PLEASE READ BEFORE COMPLETING YOUR SUBMISSION

Your submission

Kegarding the design of the sourtracing New Jetty the design proposed has limititiones. -1. impractical to 2. limited to only one boat of the time 3. Dangram to use in a southerly blam B pontoon deck constructed would have more advantagres would be easer to the Barth in a norry-NOR-west & a southerly Blow 2. (with the fecture in mind) it could berth two boats - Conclusion you would SAFER - MORE Practable - and versatile which would some akaroas weed longer than the exsisting plane - this is a good time to get it hight would have to be built in such a way NOT. TO. bump infage in a Southern blow as boats on this side pound the whaze or buildings

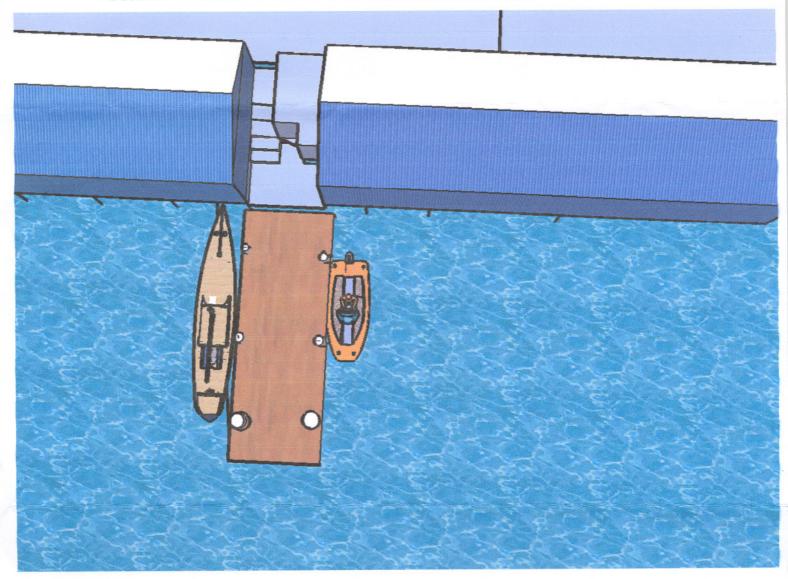
C. Would not, impact on existing users as be cause of the timitations of the Ener west allinement it is not always used or with the increased actives the extra BERH is well needed!!!

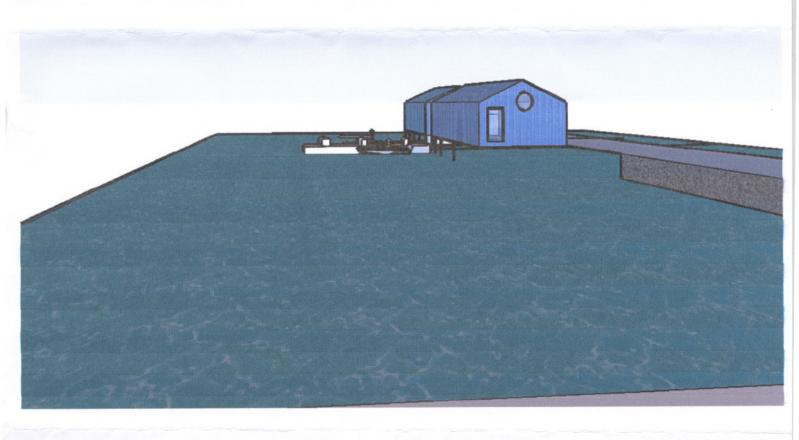
More versatile

More space will be able to handle two same time

Much safer in all wind directions

More cost effective and will cover the needs into the future

DO ONCE AND GET IT RIGHT

NOT To Scale

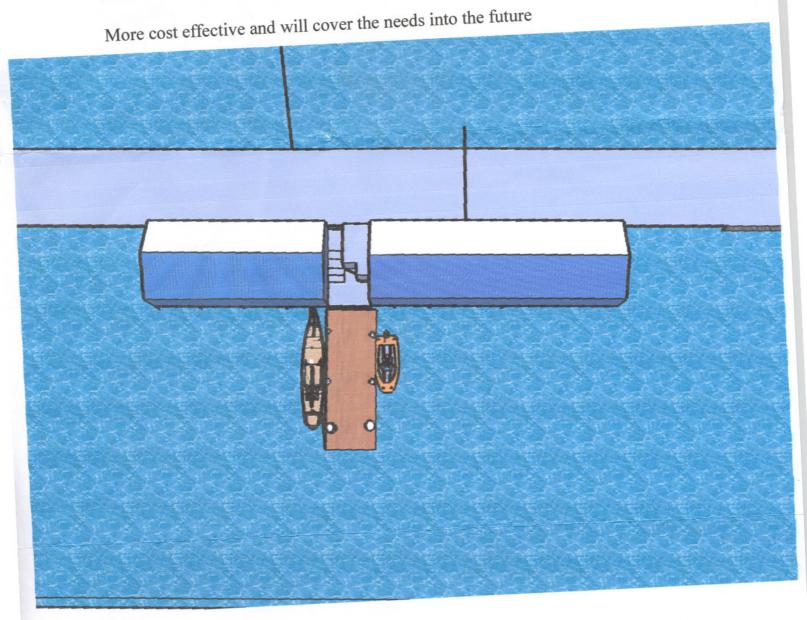
More versatile

More space will be able to handle two same time

Much safer in all wind directions

More cost effective and will cover the needs into the future

DO ONCE AND GET IT RIGHT

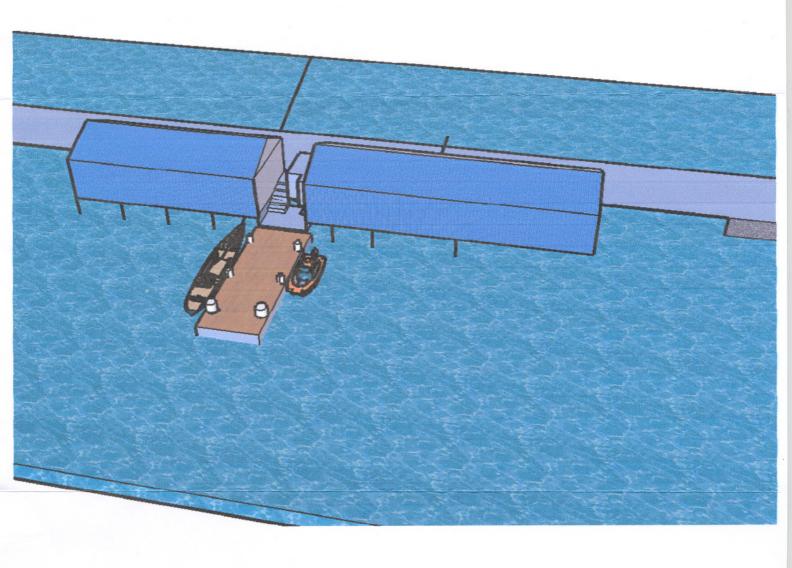
More versatile

More space will be able to handle two same time

Much safer in all wind directions

DO ONCE AND GET IT RIGHT
